**INQUIRY INTO INQUIRY INTO MUSEUMS AND
GALLERIES**

Analysis of 'Flood Study' report for new Powerhouse Museum Riverbank site in Parramatta dating from November, 2016. (07 08 2018)

The 'Flood Study' report was submitted as part of the 'Extended Final Business Case' to Cabinet by Johnstaff consultants, Minister for the Arts/various Agencies, April 2018. Document authored by Taylor Thomson Whitling Pty Ltd, engineers [TTW].

Analysis: by Dr. Lindsay Sharp

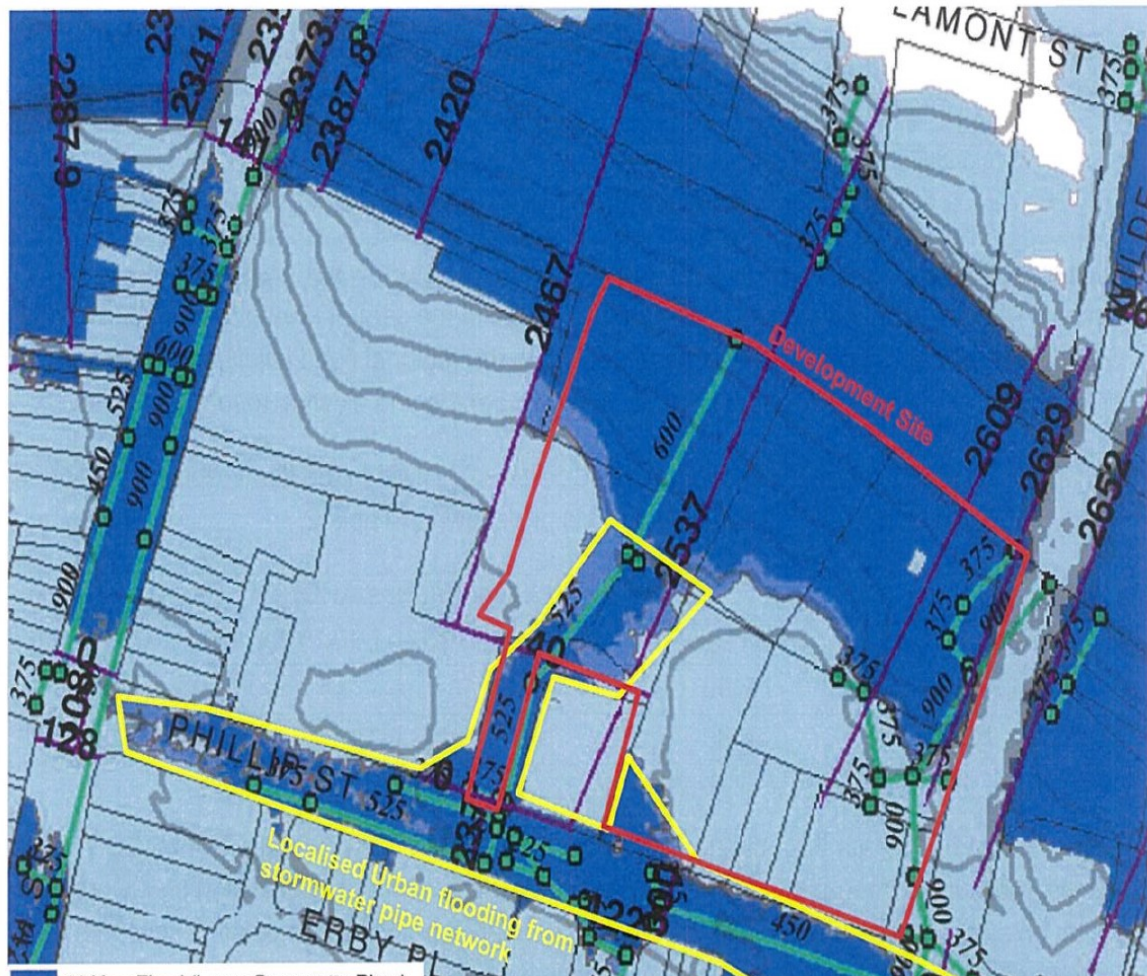
Refer below to Dr. John Macintosh's '20 year Flood Map Parramatta', taken from Macintosh's submission [174] to the Inquiry, January 2018. The Macintosh report has never been deconstructed or rejected by Government. This is obviously a matter of suspicion. The Maps produced by Dr. Macintosh versus by TTW suggest significant variations which are deeply concerning.

A 100 year flooding/maximum tidal event has not apparently been modelled insofar as that is reliably achievable at present. The rate of impact of climate change/warming on the two key ice sheets and the already embodied CO₂ in the atmosphere with its lagged warming effects are altering every six months (worst case) in a negative fashion. On that basis the map of existing flooding which follows, on a 100 year timescale, is both unhelpful and probably misleading.

Figure 5 Extract of CPC hydraulic hazard map with ground contours labelled

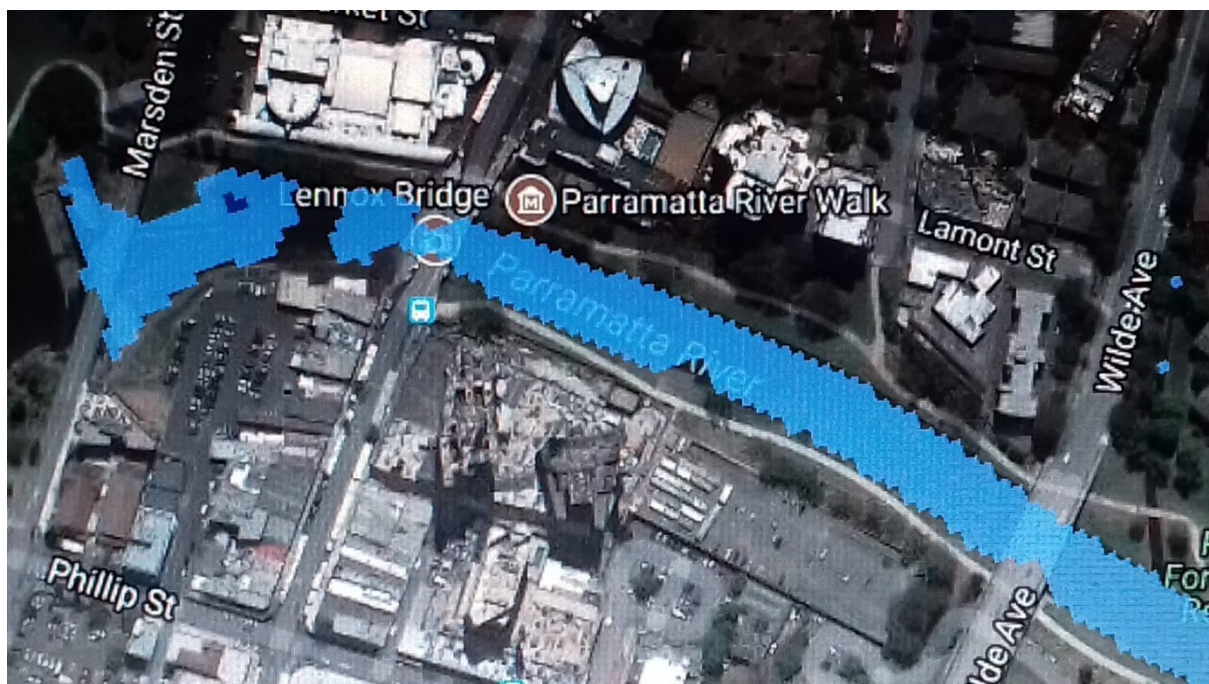
The Flood Hydraulic Hazard map which follows is perhaps even more sub-optimal:

6.1 Coastal Risk Assessment Australia 2100:

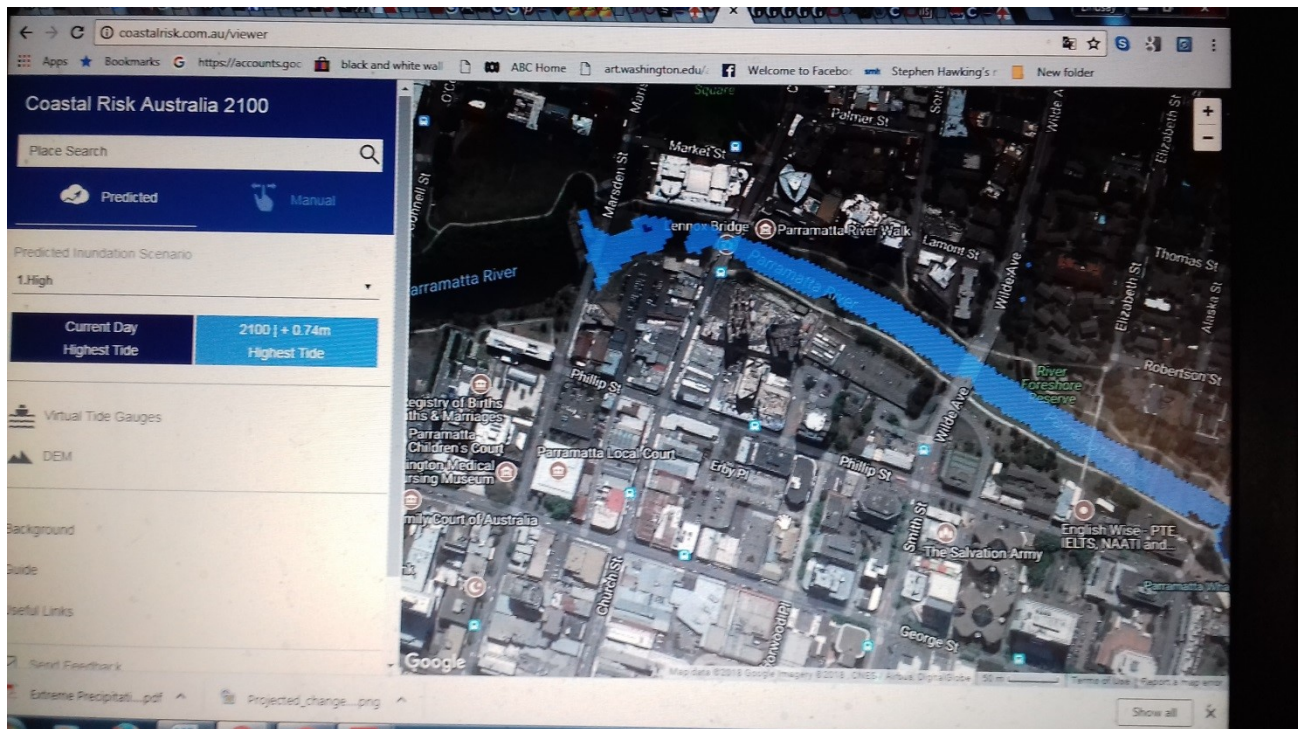
More certainty is creeping into this field and maps imaging Parramatta's risk profile in 2100 (maximum) indicate the river is indeed severely tidal this far up the waterway by this date, which has significant implications for the Riverbank site. These maps and supporting data are available on: coastalrisk.com.au/viewer, search 'Parramatta'. These are found as the 'predicted inundation scenario'; the first map gives a wider context the other is a close up.

There is no suggestion the complex flooding interplay of an epochal 100 year + flood event has been cross related here to a maximal (estimated) tidal/storm event. In the past when such occurrences have been exacerbated (East Anglia in the 1953/Holland, throughout history) by storm surges many lives have been lost after defences proved woefully inadequate notwithstanding the reassurance of authorities concerned. Equally, the new Queensland Art Gallery Building was flooded in the last few years with devastating effect, notwithstanding flood studies carried out by engineering experts prior to development. Combining such an epochal flood which will easily overwhelm the calming effect of the weir upstream at the west end of Philip Street/west of Marsden Street with a maximum tidal surge and a storm surge in a westerly direction may well have catastrophic and unmitigated effects on the new museum. Dr Macintosh has also rightly stressed the potential loss of life above all else.
